Viking CCS Pipeline

9.41 Design Changes 5 to 8: Environmental Technical Note

Document Reference: EN070008/EXAM/9.41

Applicant: Chrysaor Production (U.K.) Limited,
a Harbour Energy Company
PINS Reference: EN070008
Planning Act 2008 (as amended)
The Infrastructure Planning (Applications: Prescribed Forms
and Procedure) Regulations 2009 - Regulation 5(2)(q)
Date: June 2024

FIGURE TITLE
Figure 3
Design Change 7 - Amendment of Order limits at A18 Barton Road, near Laceby
ISSUE PURPOSE
ENVIRONMENTAL REPORT
PROJECT NUMBER / REFERENCE
60668955 / VCSS_240613_ERT_3

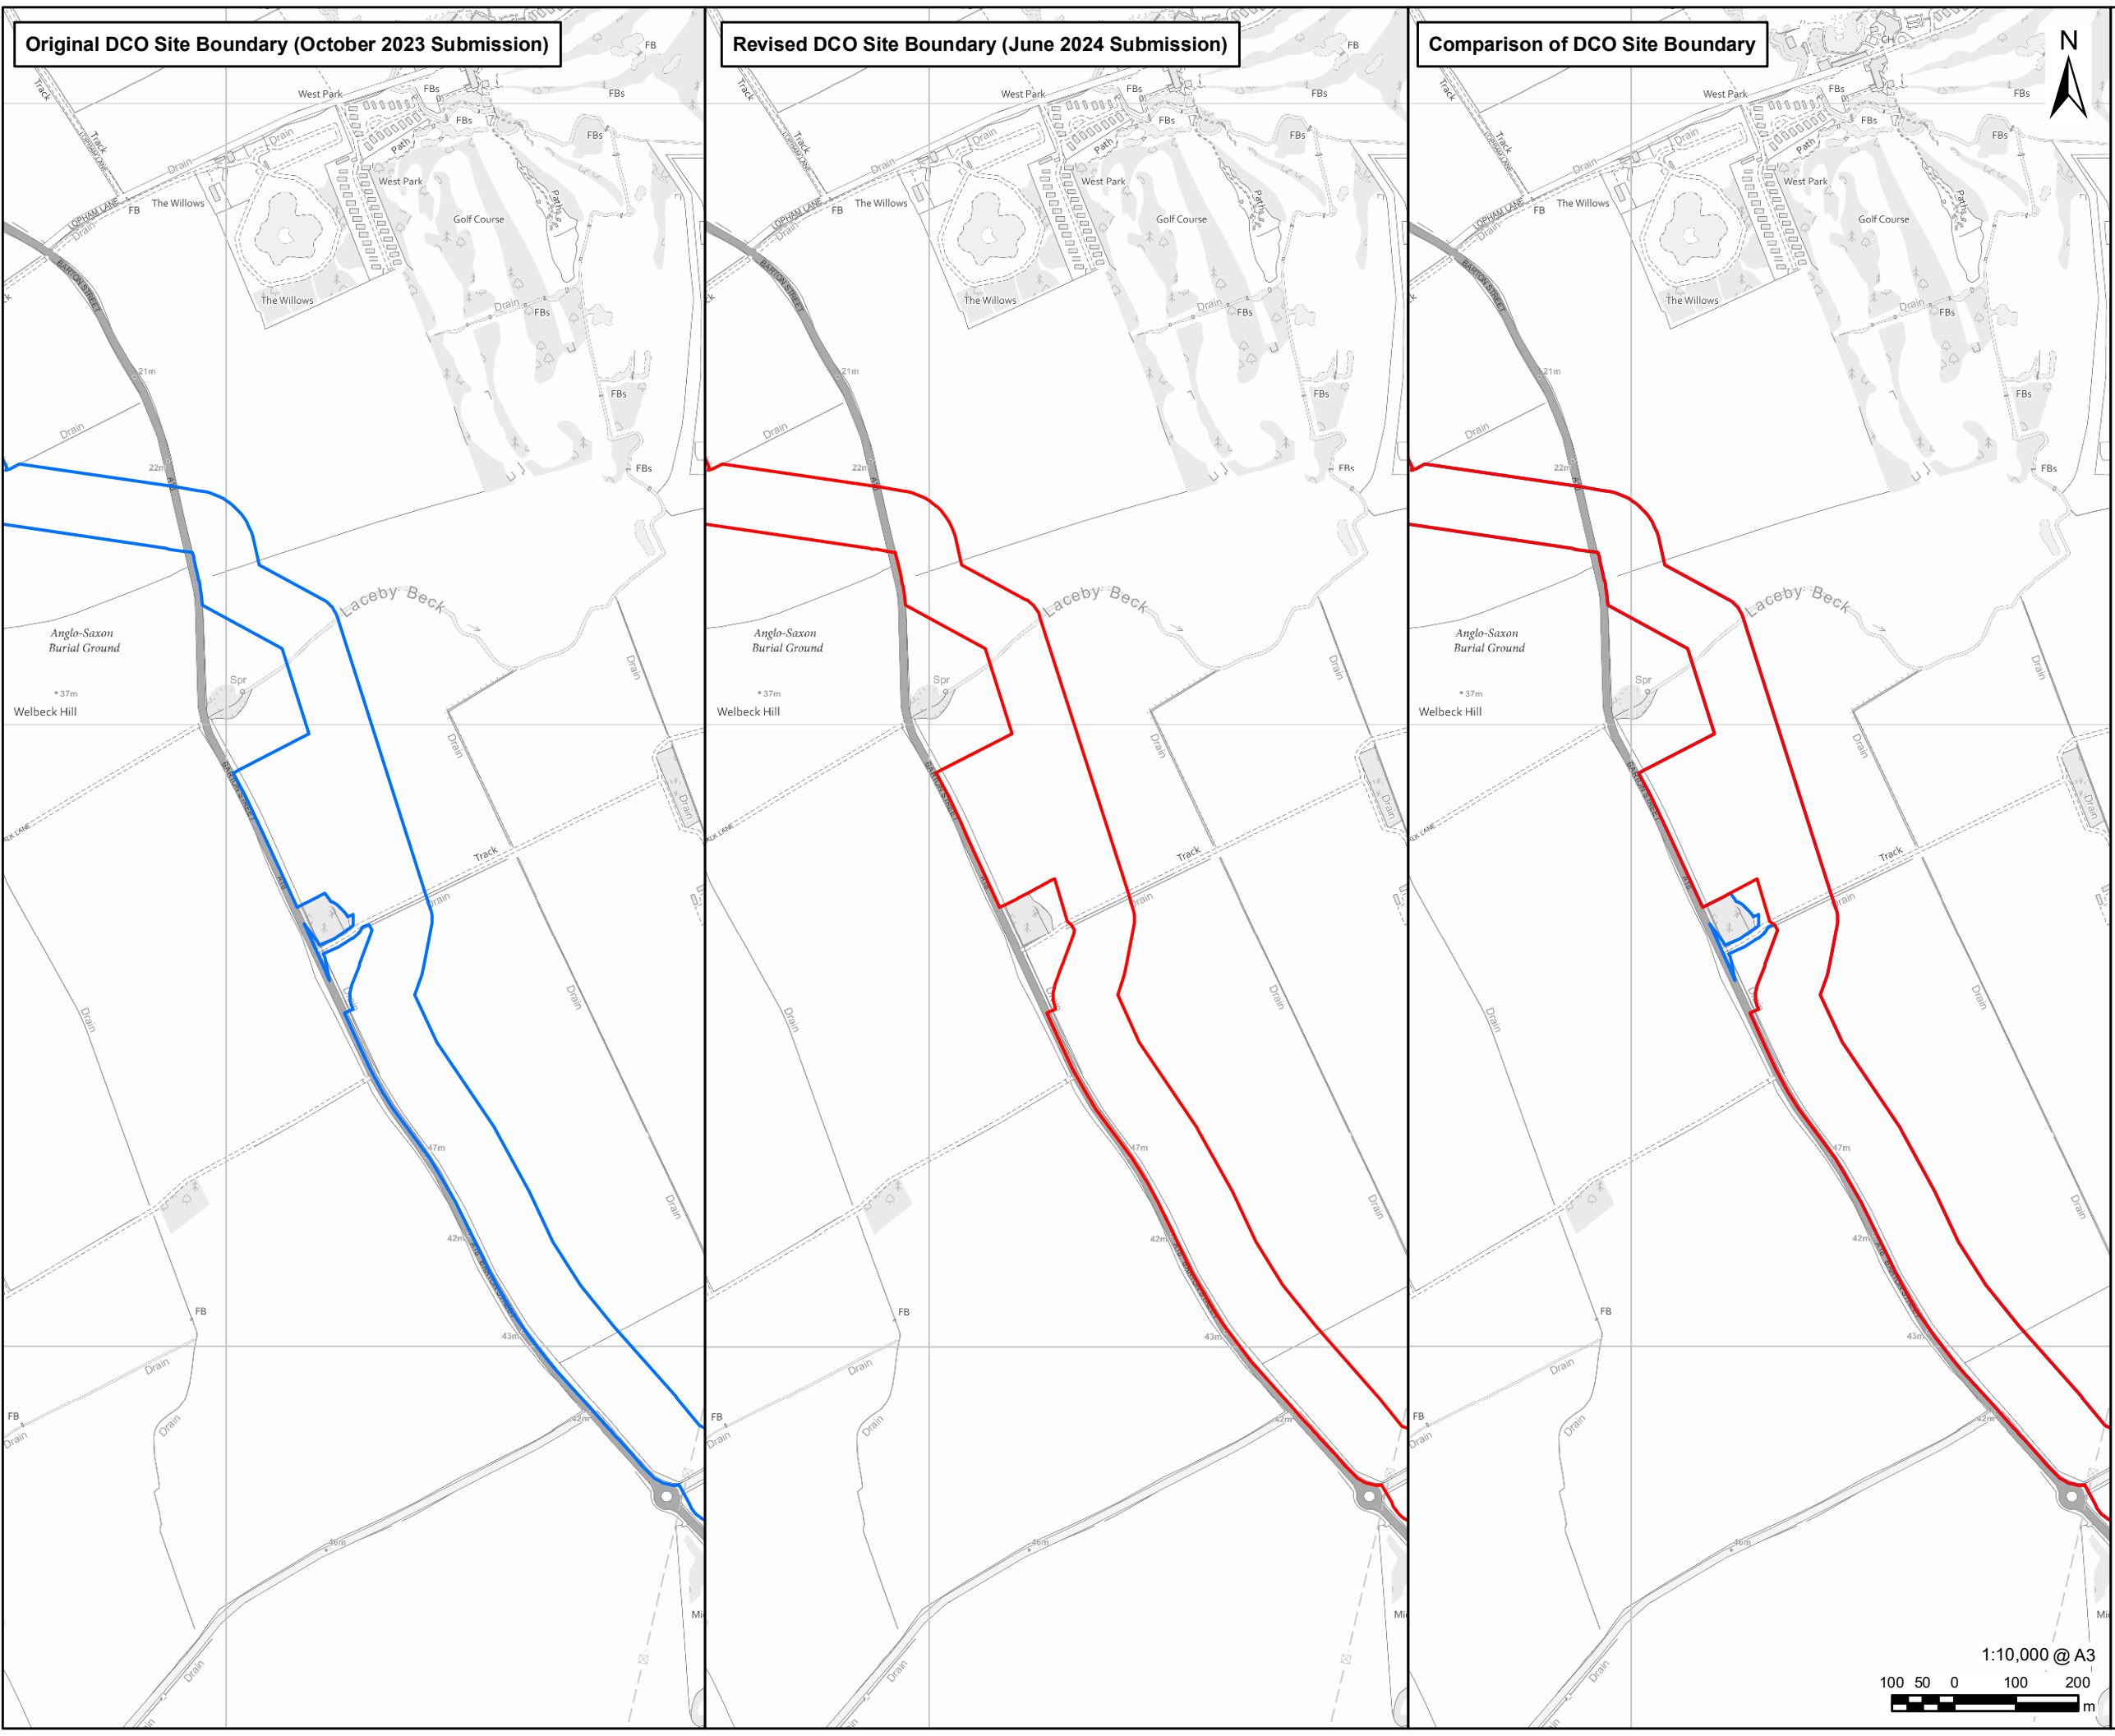
2.4 Design Change 7: Removal of a construction access point on A18, south of Laceby

- 2.4.1 The Proposed Development includes a number of vehicle access points along the route of the pipeline that will be used during the construction stage for the delivery of construction materials and plant. The Applicant has engaged with the Local Highway Authorities during the examination period. During these discussions, North East Lincolnshire Council has raised concern that adequate visibility may not be available for drivers entering and exiting construction access 12-AB leading east from the A18 in North East Lincolnshire. It is proposed that this access is to be removed from the Proposed Development and the Order Limits reduced accordingly.

- 2.4.2 This change would result in a reduction of the Order Limits associated with Works No.16a. The change would reduce the area of land included in the Order Limits and would not engage any new land interests. No additional land outside of the current Order Limits is required. This change would not result in new or different likely significant environmental effects reported in the ES.

Figure 4
Design Change 8 - Amendment of Order Limits at A46, west of Laceby

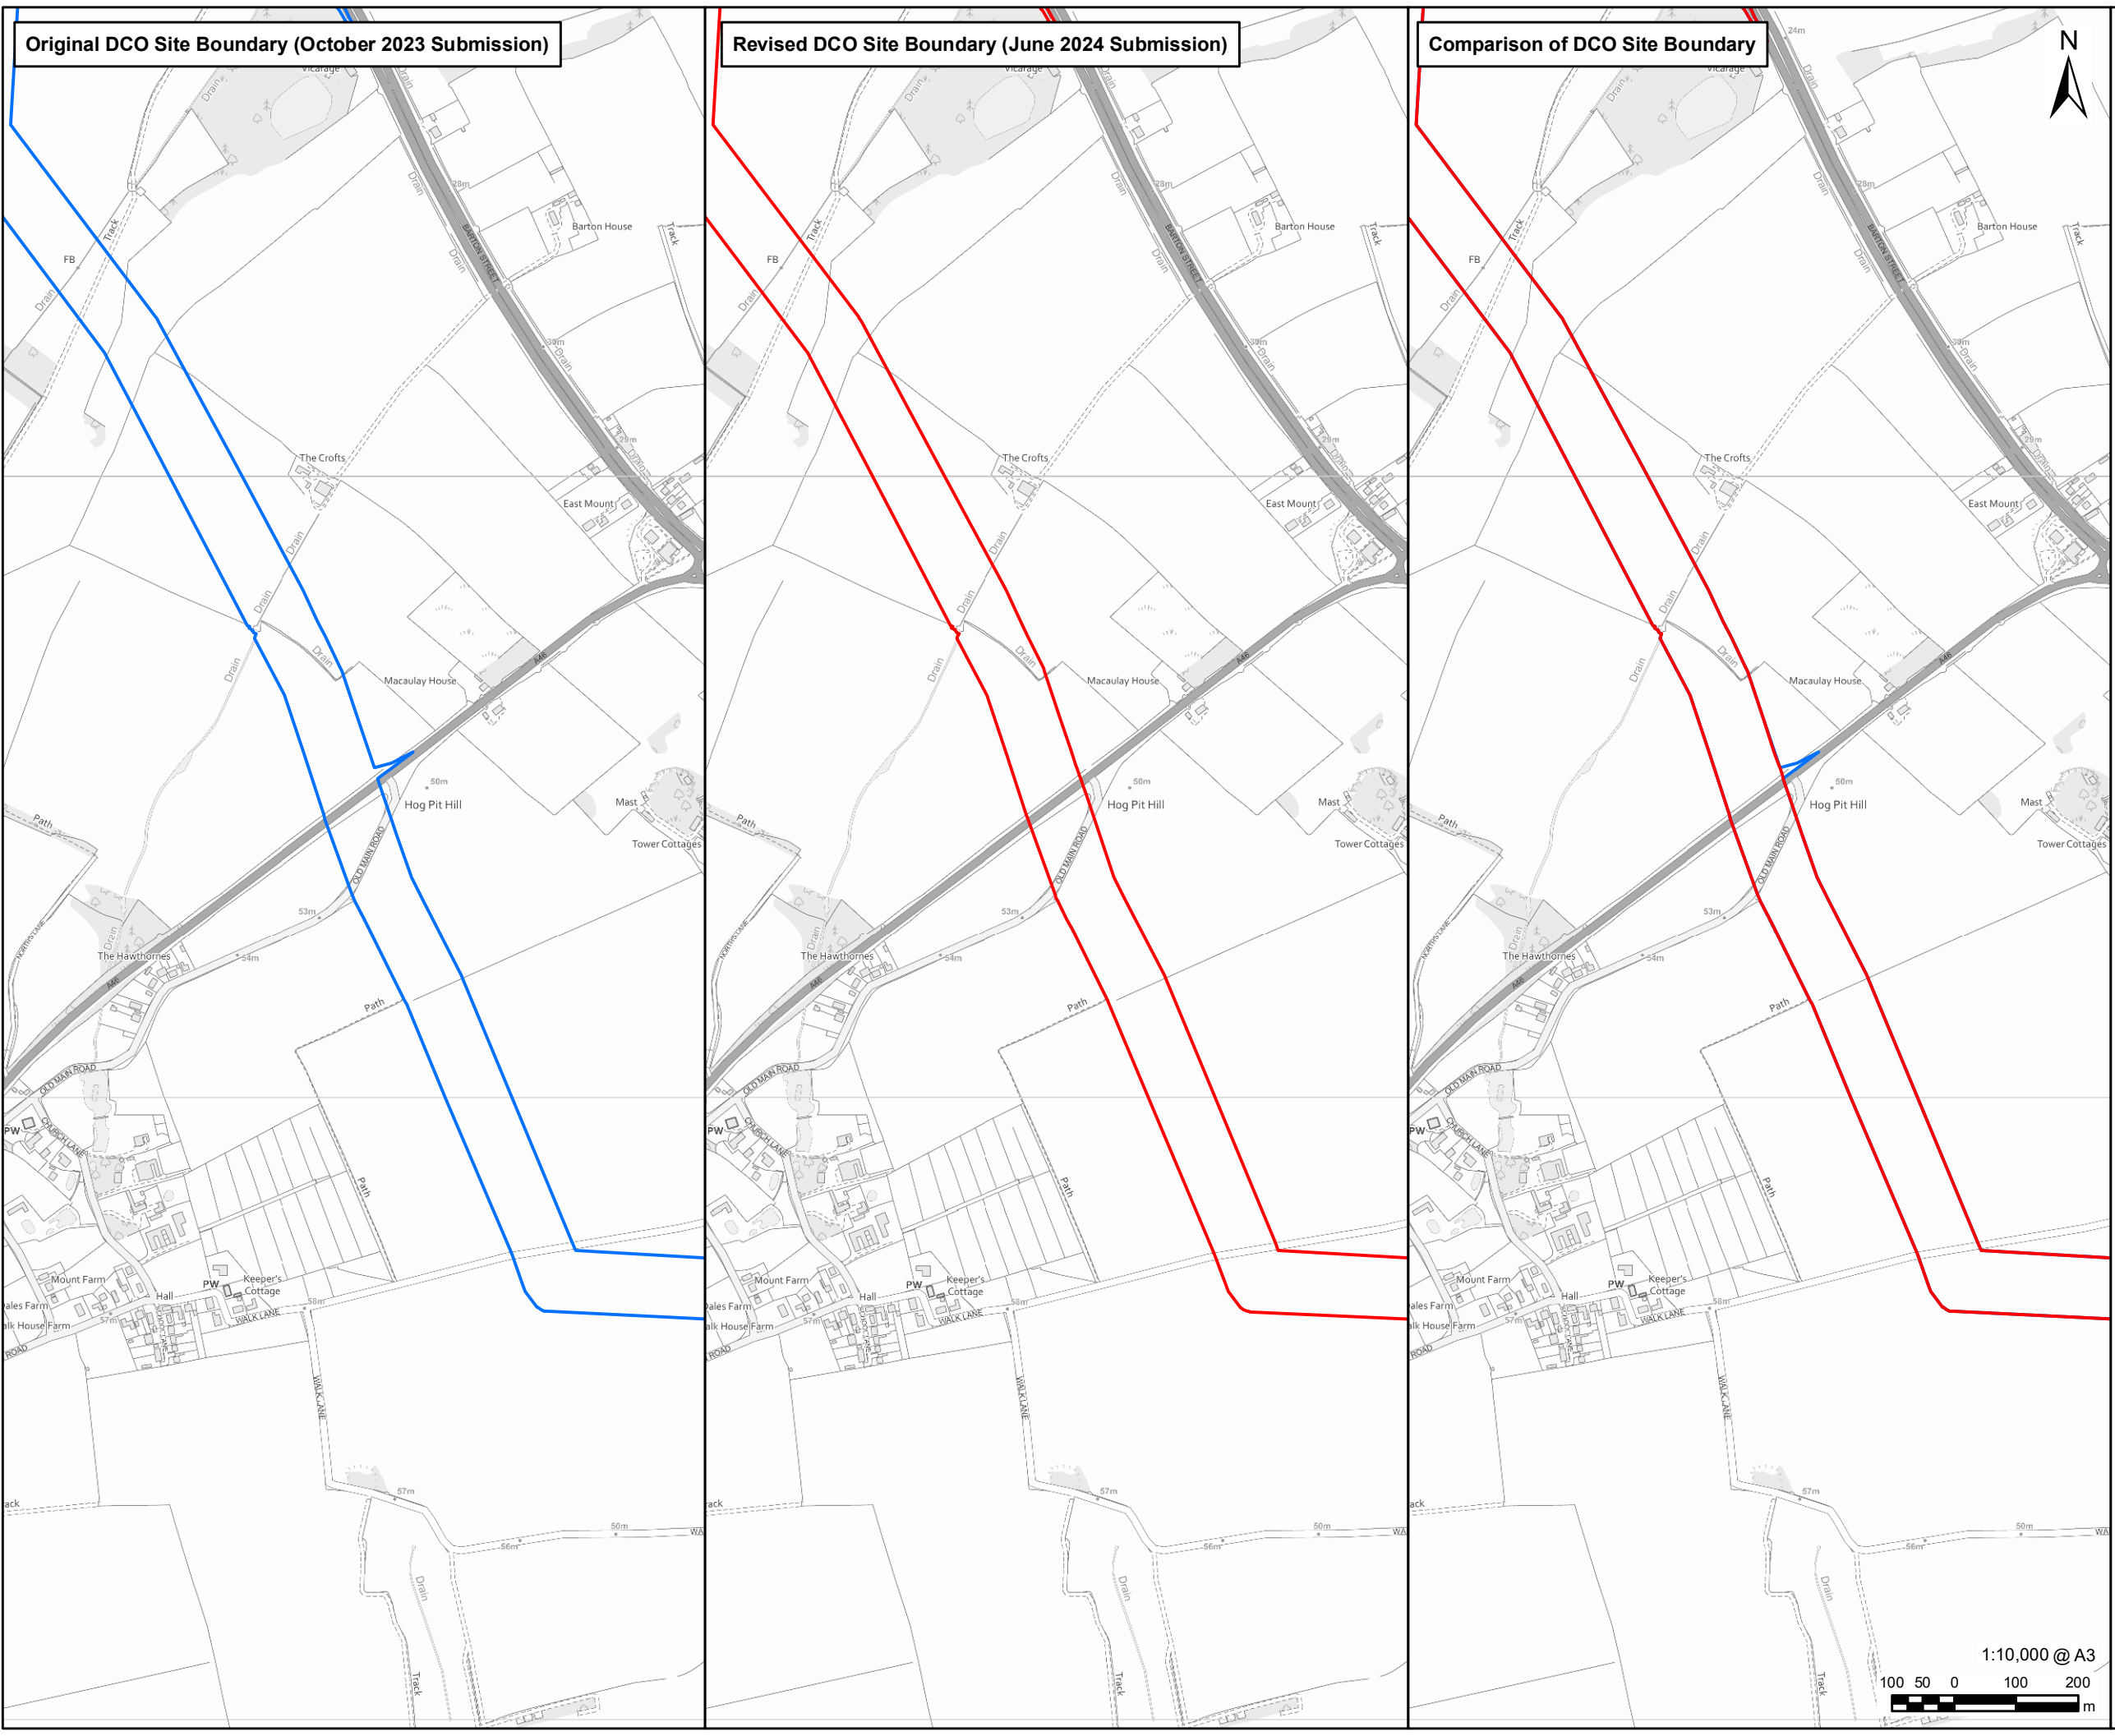
2.5 Design Change 8: Removal of a construction access point on A46, west of Laceby

- 2.5.1 During discussions with the Local Highway Authority, North East Lincolnshire Council has also raised concern that adequate visibility may not be available for drivers entering and exiting construction access 11-AD leading north from A46. It is proposed that this access is removed from the Proposed Development and the Order Limits reduced accordingly.

- 2.5.2 This change would result in alterations to the Order Limits associated with the above Works Nos. The change would reduce the area of land included in the Order Limits and would not engage any new land interests. No additional land outside of the current Order Limits is required. This change would not result in new or different likely significant environmental effects reported in the ES.
